GNRO-2014/00055

SUBJECT: Entergy's Third Six-Month Status Report in Response to March 12, 2012 Commission Order Modifying Licenses with Regard to Reliable Spent Fuel Pool Instrumentation (Order Number EA-12-051)
Grand Gulf Nuclear Station, Unit 1
Docket No. 50-416
License No. NPF-29

**Grand Gulf Nuclear Station's Third Six Month Status Report for the
Implementation of Order EA-12-051, Order Modifying Licenses with Regard to
Requirements for Reliable Spent Fuel Pool Instrumentation**

Figure 1: SFP Plan View

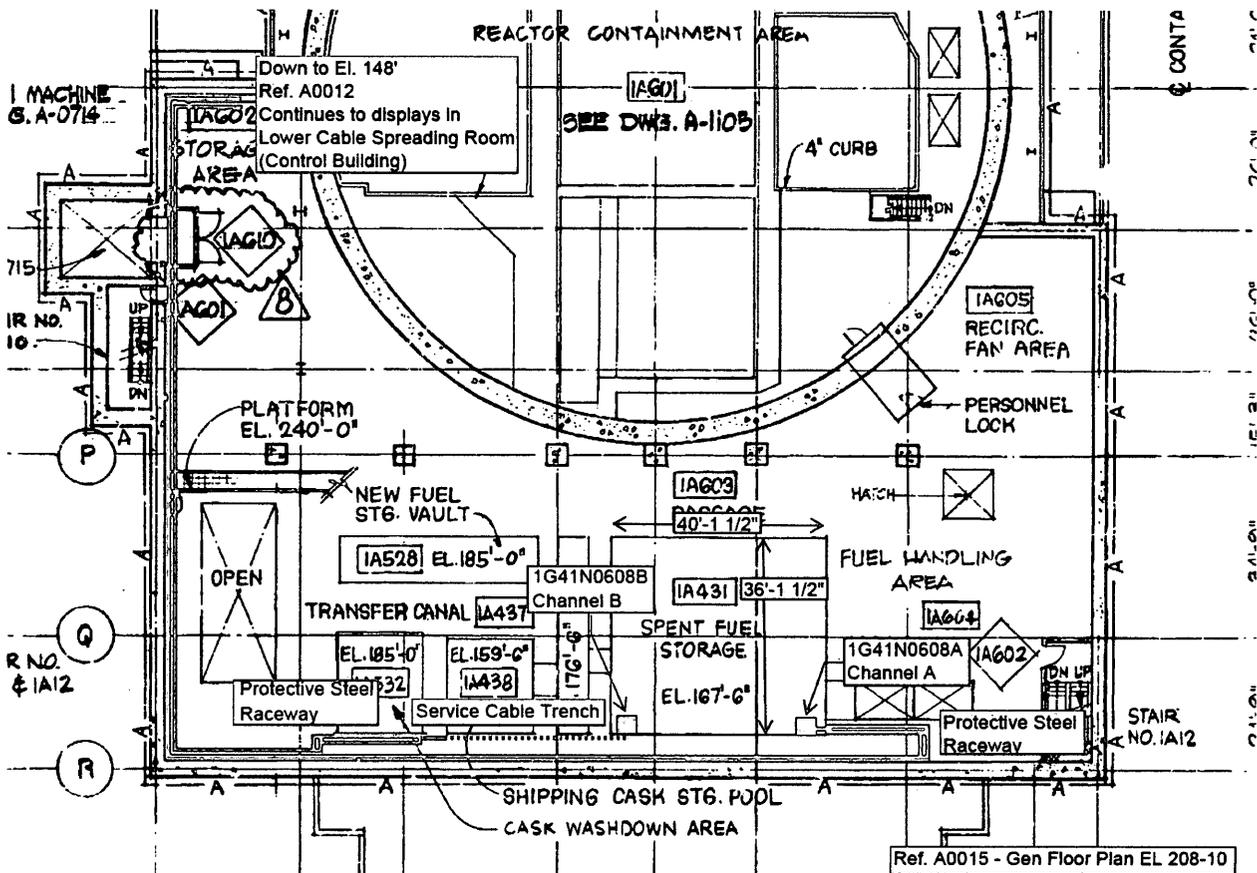
Please provide a clearly labeled sketch or marked-up plant drawing depicting the proposed routing of the cables that will extend from the SFP sensors toward the location of the read-out/display device in the computer and control panel room.

Section 7 of the OIP refers to Attachment 1 for the approximate locations of the level instruments. Attachment 1 of the original OIP shall be superseded by Figure 1 in RAI #2 in Section 9 of this update. Refer to the response in RAI #2 of Section 9 for additional details regarding the SFPI probe arrangement and the separation between the two instrument channels.

The read-out/display device will be located in the lower cable spreading room. Figure 1 shows the approximate locations of the SFPI probes (in the northwest and southwest corners), the inside dimensions of the SFP, and the proposed cable routing. Along the walls where the conduits from each channel appear to run together, the conduits are separated vertically, using completely separate supports.
